Access Compliance Report

Public Rights-of-Way

(Curb Ramps)

Intersection ID: 10011809	Main Street: STATESVILLE_RD	Cross Street: N/A	Location: NE
ADA ID: FA8900FD4B05	Ramp Type: Perp	Initial Pass/Fail: Fail	Overall Compliance: No
Severity Score: 8.75			
Codes/Mitigation Info/Possible Solution		Field Measurements/Component Compliance

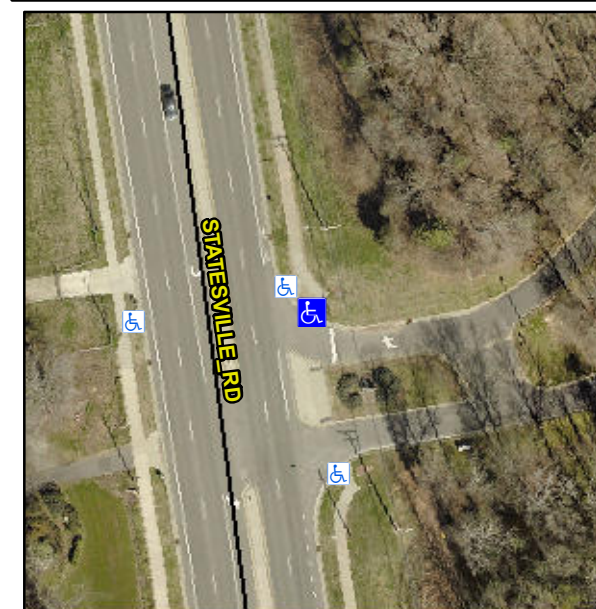
Not Found, R304.5.1

Compliance	Description	Data	Compliance	Description	Data
N/A	Ramp Length (in)	102.0	Yes	Ramp Slope (%)	6.8
No	Ramp Width (in)	47.0	Yes	Ramp XSlope (%)	0.2
N/A	Flare Type LT	N/A	N/A	Flare Type RT	N/A
N/A	Flare Slope LT (%)	N/A	N/A	Flare Slope RT (%)	N/A
N/A	Flare Traversable LT?	N/A	N/A	Flare Traversable RT?	N/A
N/A	Landing Length (in)	N/A	N/A	DWS Provided?	N/A
N/A	Landing Width (in)	N/A	N/A	DWS Contrast?	N/A
N/A	Landing Slope (%)	N/A	N/A	DWS Length (in)	N/A
N/A	Landing X Slope (%)	N/A	N/A	DWS Full Width?	N/A
N/A	Landing Curb? (Y/N)	N/A	N/A	DWS Offset (in)	N/A
N/A	Shared Landing?	N/A			
N/A	Gutter Ponding?	N/A	N/A	Gutter Slope (%)	N/A
N/A	Gutter Lip Ht (in)	N/A	N/A	Gutter X Slope (%)	N/A
N/A	Painted X Walk1?	No	N/A	Painted X Walk2?	N/A
	X Walk 1 Direction	To S		X Walk 2 Direction	N/A
N/A	X Walk 1 Width (in)	N/A	N/A	X Walk 2 Width (in)	N/A
	X Walk 1 Slope (%)	1.0		X Walk 2 Slope (%)	N/A
	X Walk 1 X Slope (%)	0.4		X Walk 2 X Slope (%)	N/A

Remove & Replace Entire Ramp.
